WANG

M-E-M-O-R-A-N-D-U-M

TO: Northeast Area ATS's & DTS's
FROM: Bill Dini
DATE: April 24, 1981
SUBJECT: Series 24 TB216A FTU

PERIPHERALS-DISK DRIVES-CDC PHOENIX 9448 CMD.

Figure 1. Base Pan Cutaway Showing Base Pan Signal Harness and Power Supply Connector PS1P1

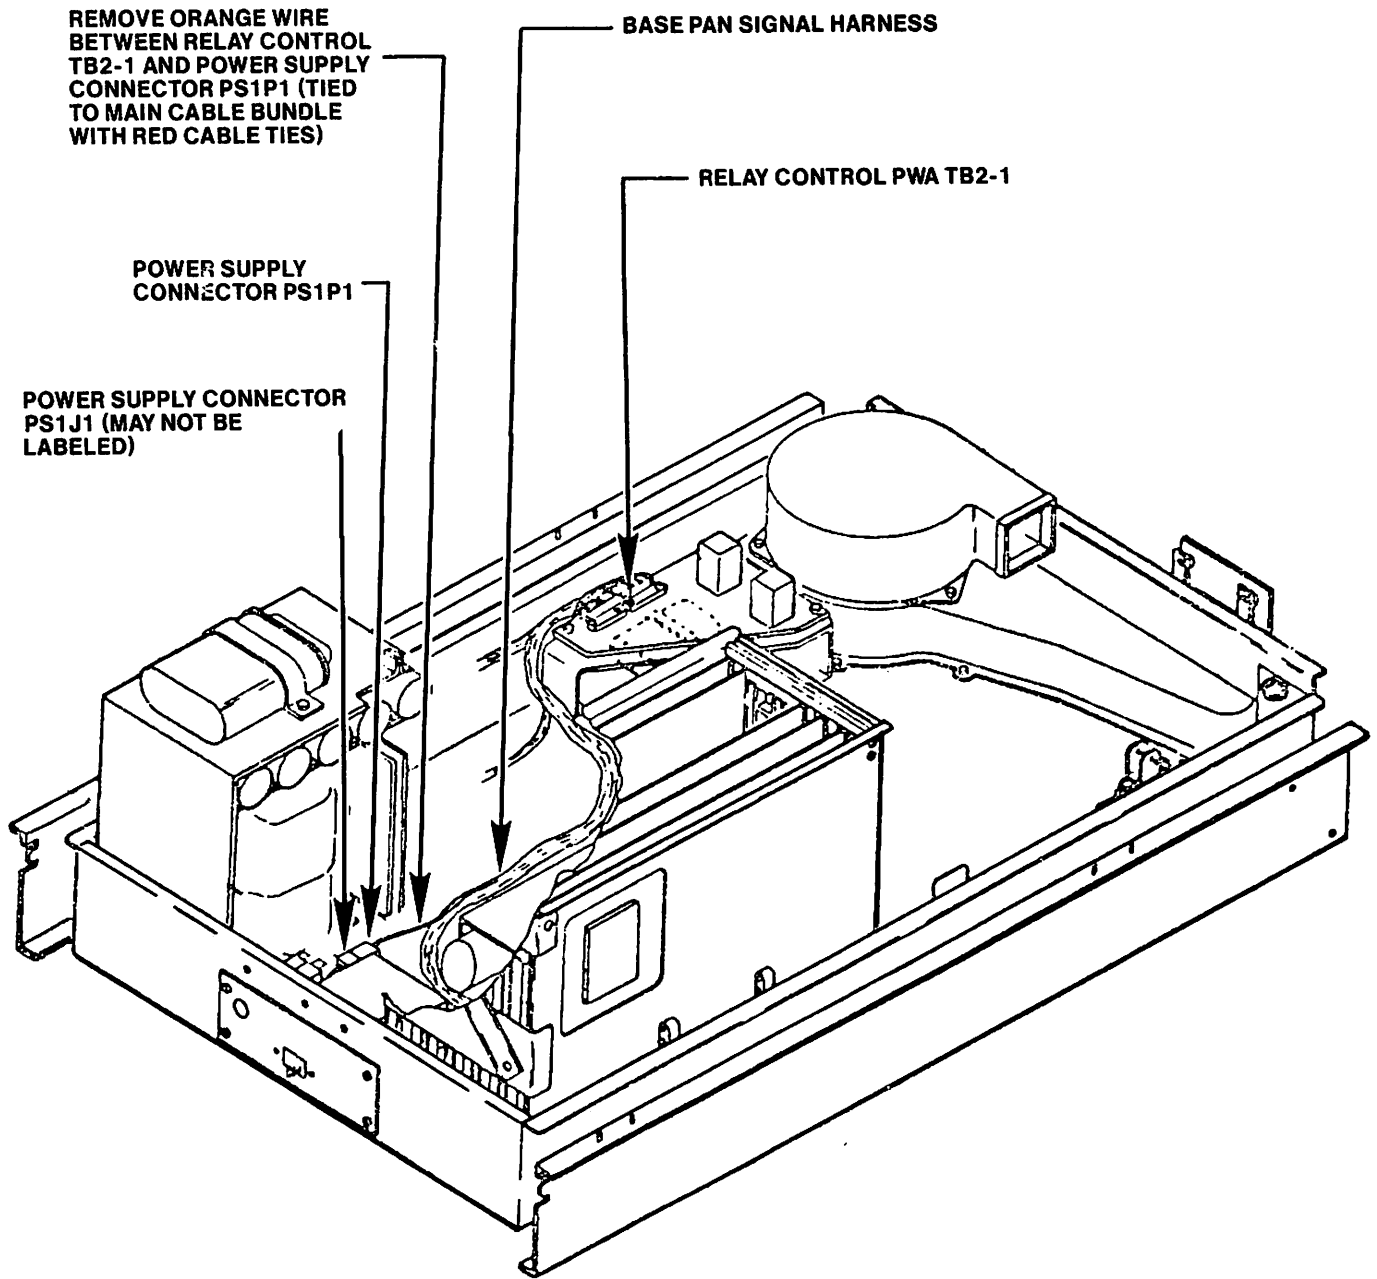
1. Remove failed power supply according to procedure in paragraph 6.7.15.3 of affected manual (WLI P/N 729-0198).
2. Refer to figure 1 and proceed as follows:

- c. Disconnect orange wire from terminal RCTB2-1 and from pin 2 of power supply connector PS1P1.
 - d. Remove orange wire from base pan signal harness.

- e. Using Amp Pin Extractor Tool No. 458994-1 or small screwdrivers, remove pin 2 from power supply connector PS1P1.
 - f. Identify wire in base pan signal harness with three-pin connector marked PS1-P4 on one end. Other end is bent back and covered with heat shrinkable tubing.

- g. Remove heat shrinkable tubing from wire identified in last step, and solder end marked RCTB2-1 to terminal RCTB2-1 in place of orange wire disconnected in step 2c.

Figure 3. Power Supply Showing Connection for New Connector PS1P4

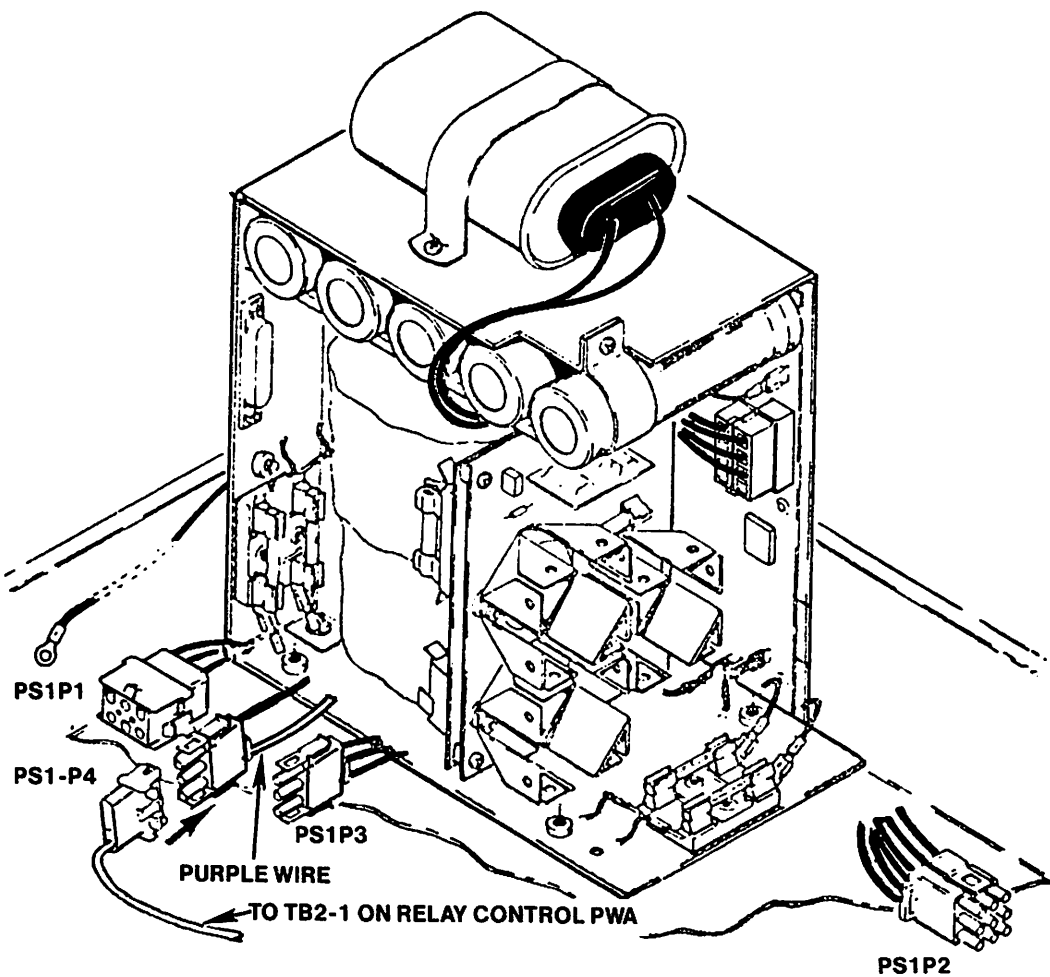
3. Refer to figure 3 and insert connector PS1-P4 into power supply connector PS1P4.
4. Use procedure in paragraph 6.7.2 of affected manual (WLI P/N 729-0198) to:
 - a. Lower deck assembly from maintenance position into normal position.
 - b. Restore electronics module to its normal position.

FIGURE 1. THREE POSSIBLE CONFIGURATIONS OF DAISY CHAINED MIXED SMD/CMD AND ALL CMD DISK DRIVE SYSTEMS

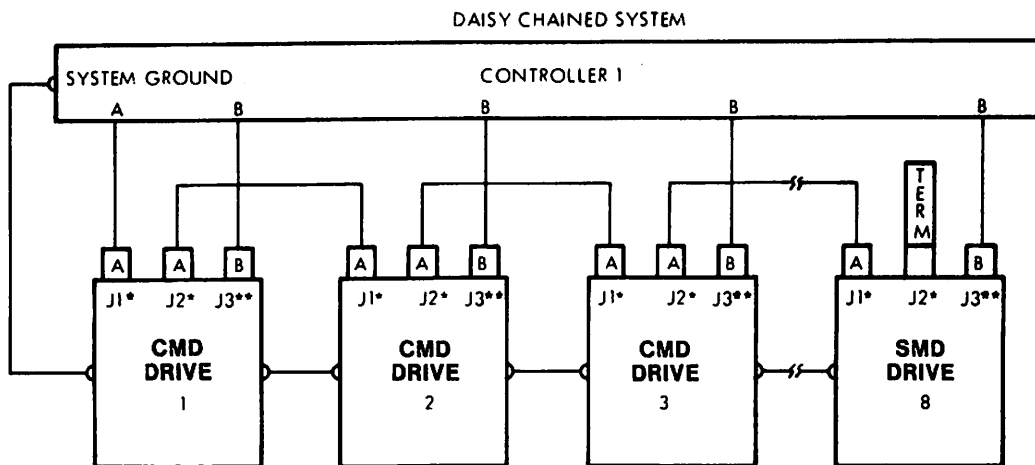
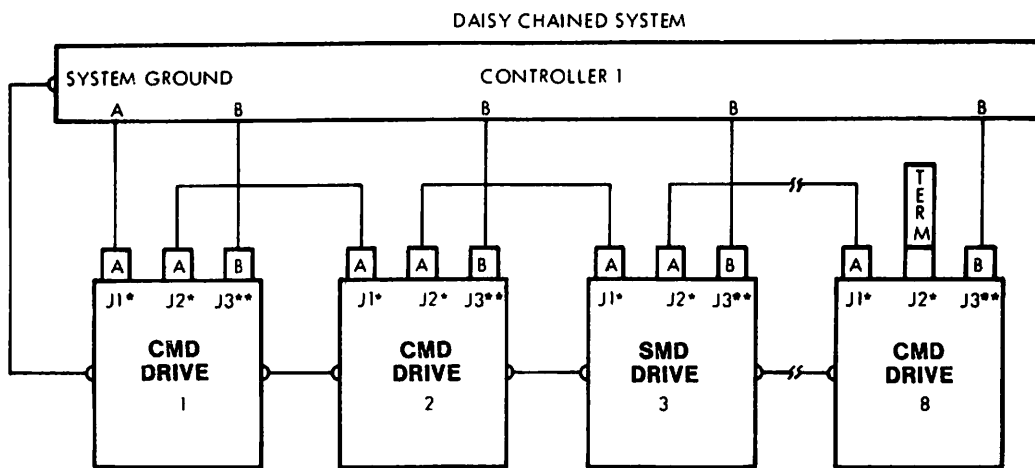
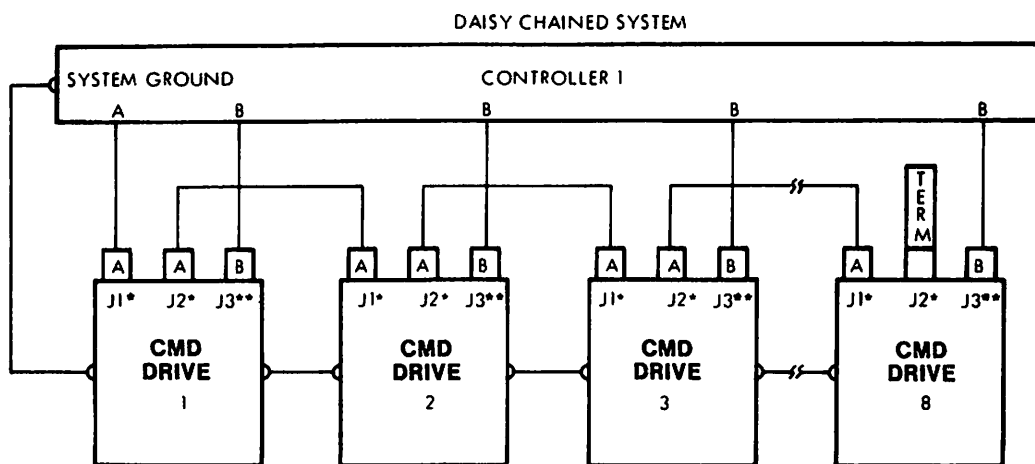
- a. If the SMD unit is the last unit of the daisy chain in a mixed SMD/CMD VS System (see figure 1A) there is no terminator compatibility problem.

- b. If the CMD unit is the last unit of the daisy chain in a mixed SMD/CMD VS System (see figure 1B) the following three corrective options are available:
 1. Rearrange the SMD/CMD units so that an SMD unit is the last unit in the daisy chain
 2. Replace incompatible terminator (726-5790 or 75886100) with compatible terminator (WANG P/N 210-7177 or 210-7477)
 3. Modify terminator 726-5790 or 75886100 as described in paragraph 3 and shown in figure 2
- c. If the VS System has only CMD units in the daisy chain (see figure 1C), the terminator must be either replaced with a compatible terminator or the existing terminator modified to be made compatible as described in paragraph 3 and shown in figure 2.

FIGURE 2 MODIFICATION OF INCOMPATIBLE TERMINATORS 726-5790 AND 75886100.

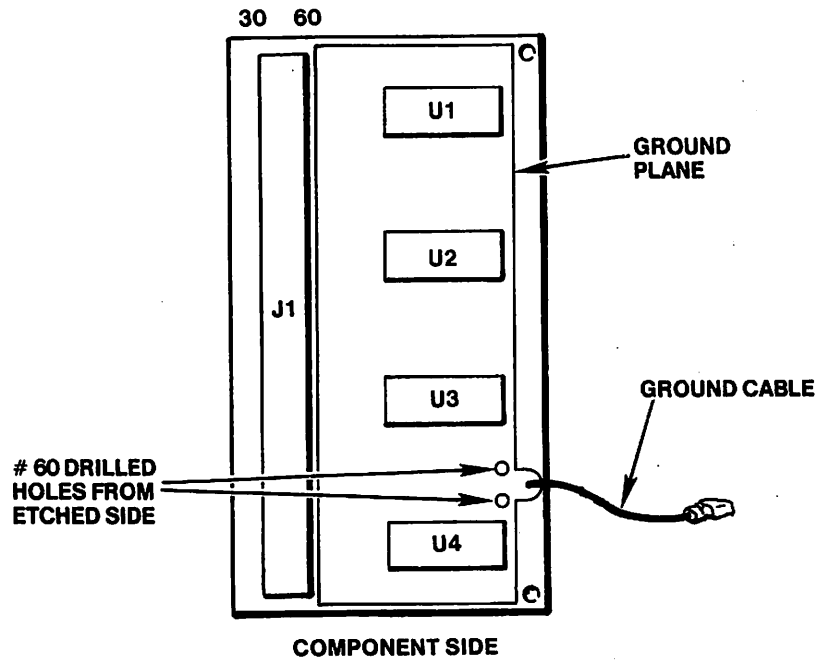
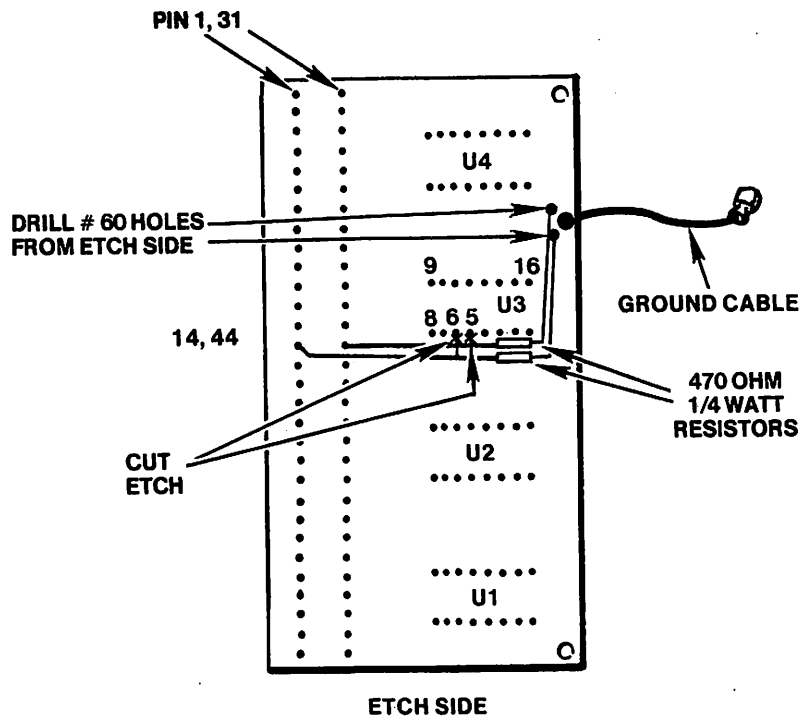
This PSN supercedes PSN III.A.7-4 (729-0993) to correct its instructions as noted by vertical black bars to the right of the corrected text and the error in figure 2.

- a. Using the pin vise and #60 drill, drill two holes from the etch side (one on each side of the ground cable) through the ground plane on the opposite side of the PWA as shown in figure 2.
- b. Cut the etches leading from pins 14 and 44 of connector J1 at pins 5 and 6 respectively of resistor pack U3 as shown in figure 2.
- c. Slide insulators on the both leads of the two 470 ohm resistors and solder one end of one resistor to the etch leading from pin 14 and one end of the other resistor to to the etch leading from pin 44 of connector J1 as shown in figure 2.
- d. Insert the remaining end lead of each of the two resistors through the two holes drilled through the PWA and ground plane and then solder as shown in figure 2.

FIGURE 1 ELECTRONICS MODULE/A-CABLE TERMINATOR LOCATIONS

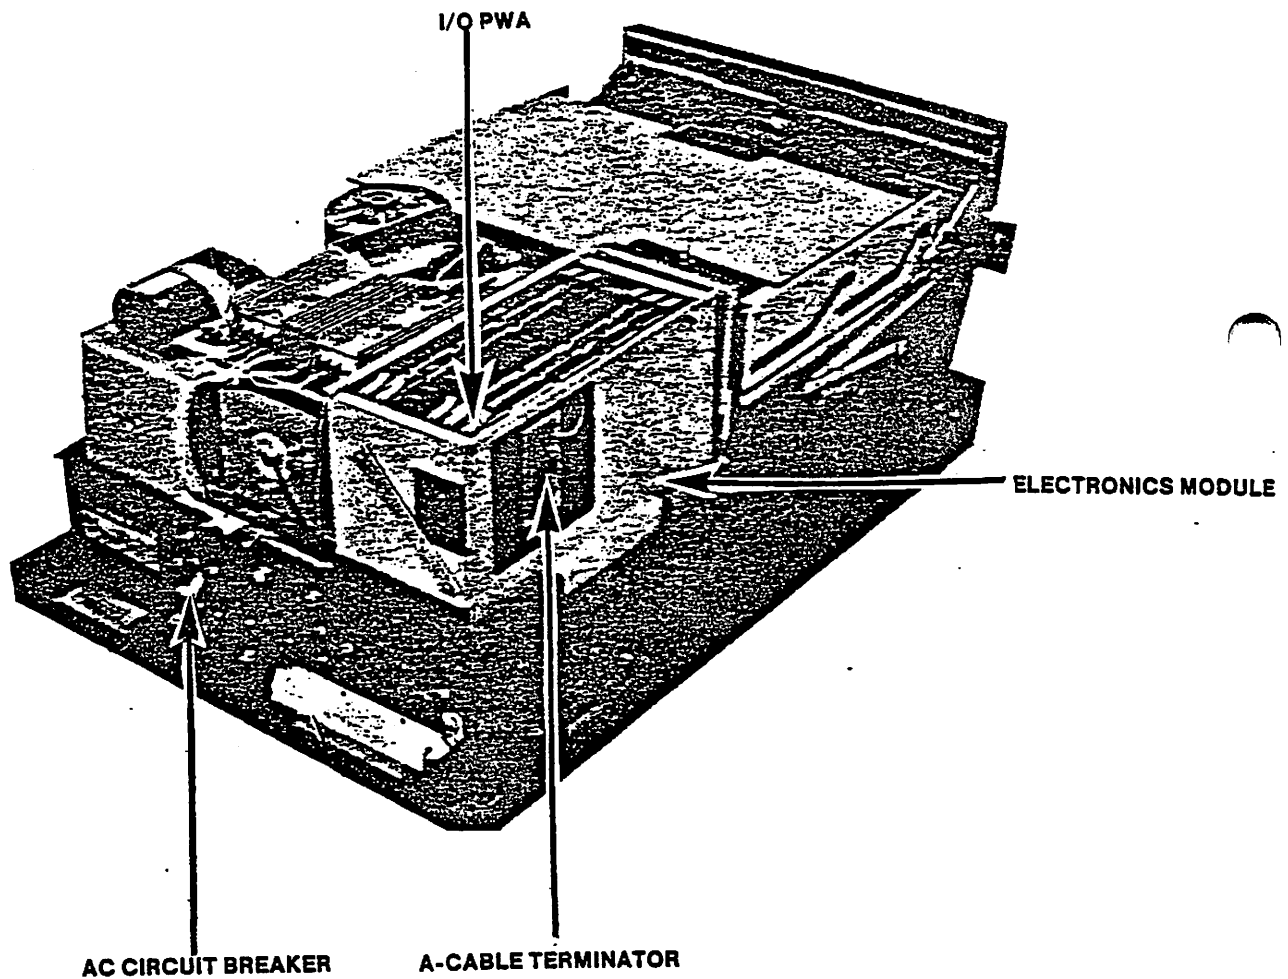
- * Remove CDC CMD PCB #75886100 (WLI 726-5790) and replace with 210-8017 PCB.

- * E. Refer to Figure 1. Remove the A-Cable Terminator, CDC CMD PCB #75886100 (WLI 726-5790), from the I/O J2 slot of the I/O PWA in the electronics module.
- F. Install the new A-Cable Terminator 210-8017 PCB in the I/O J2 slot of the I/O PWA in the electronics module. Insure that cable is properly attached.
- G. Run Check-Out Procedure described in Section 6 below.
- H. Replace dust cover and install screws.
- I. Replace furniture cover.
- J. Document installation of FCO by completing a Call Report or Activity Report.

FIGURE 1 ELECTRONICS MODULE/A-CABLE TERMINATOR LOCATIONS

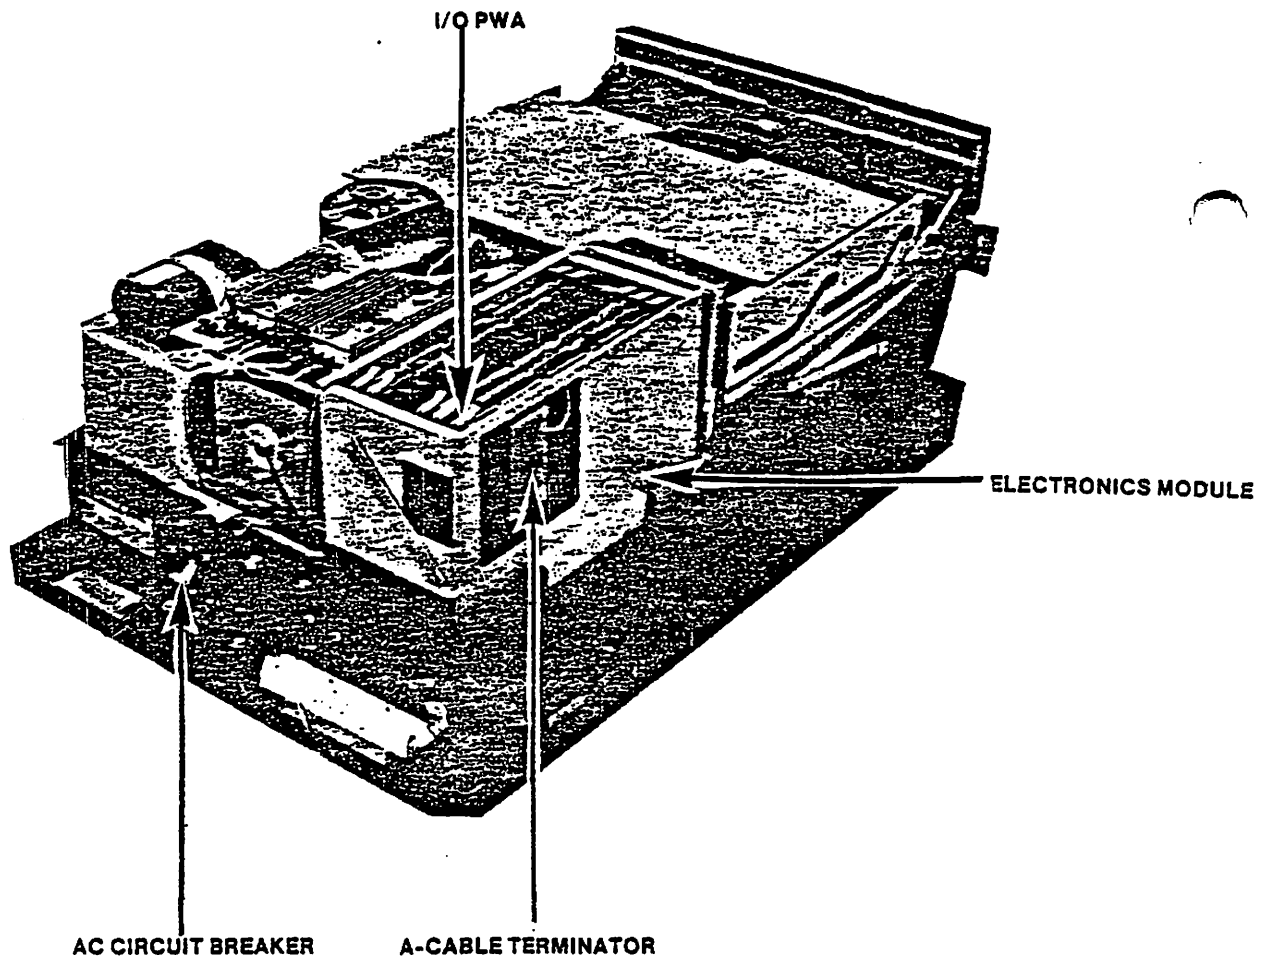
Remove CDC CMD PCB #75886100 and replace with 210-8017 PCB.

- E. Refer to Figure 1. Remove the A-Cable Terminator, CDC CMD PCB #75886100, from the I/O J2 slot of the I/O PWA in the electronics module.
- F. Install the new A-Cable Terminator 210-8017 PCB in the I/O J2 slot of the I/O PWA in the electronics module. Insure that cable is properly attached.
- G. Run Check-Out Procedure described in Section 6 below.
- H. Replace dust cover and install screws.
- I. Replace furniture cover.
- J. Document installation of FCO by completing a Call Report or Activity Report.

FIGURE 1

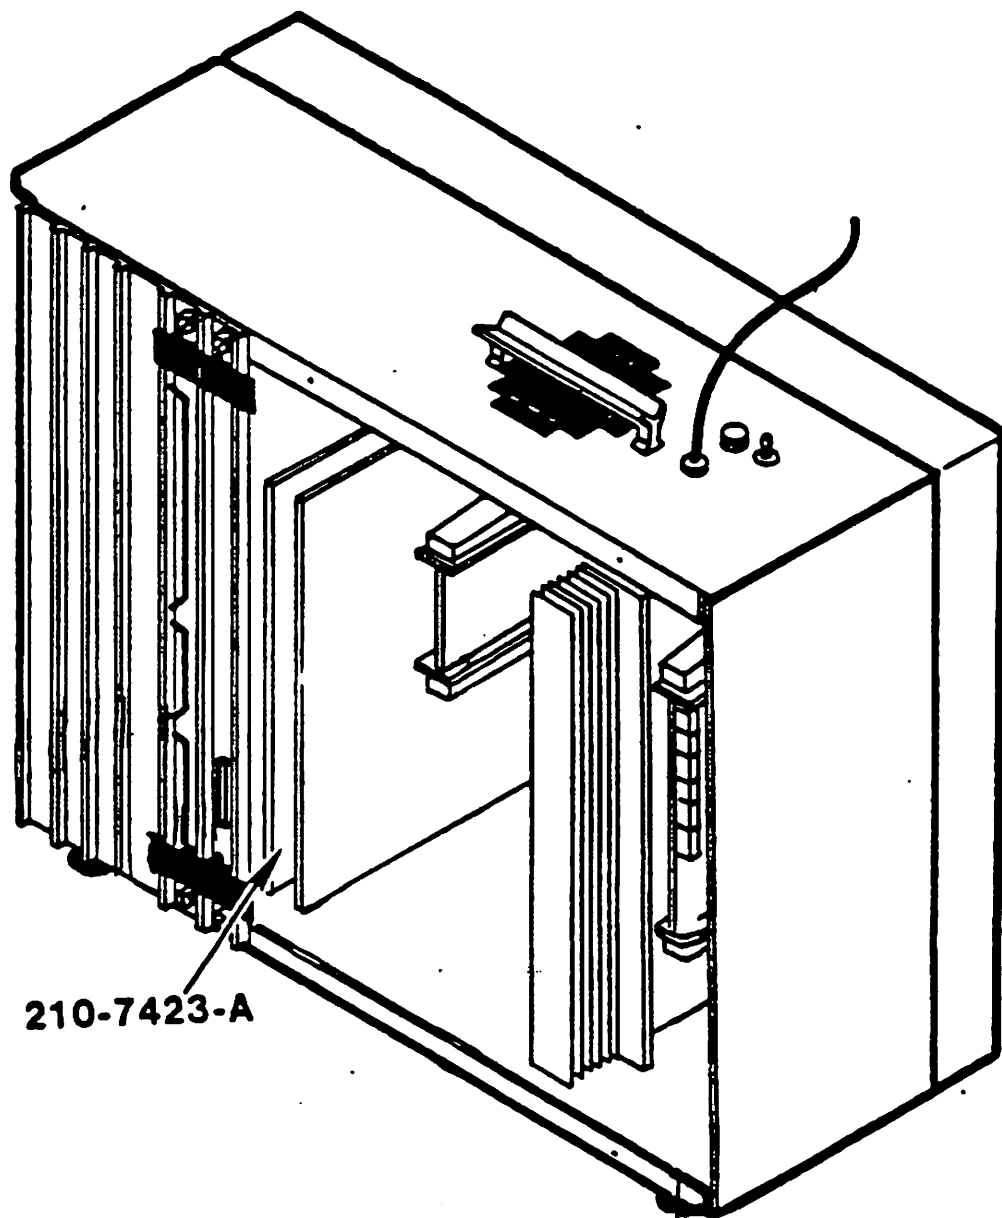
- A. Power off. Remove AC plug at wall.
- B. Refer to "Customer Engineering Maintenance Manual" (729-0971) p.4.3, sections 4.5 through 4.5.1 for top cover removal/replacement procedures.
- C. Refer to Figure 1. Remove the 210-7423-A PCA from the Disk Processing Unit (DPU).
- D. Refer to Figure 2. Change PROM's on the 210-7423-A PCA as follows:
 - 1. Component Side:
 - a. Change L13 to 378-4083-R8.
 - b. Change L14 to 378-4084-R8.

- c. Change L15 to 378-4085-R8.
- d. Change L16 to 378-4086-R8.
- E. Reassemble the unit by reversing the procedures in Steps A through C.
- F. Perform check-out procedure described in Section 6 below.
- G. Document installation of this FCO by completing a Call Report or Activity Report.
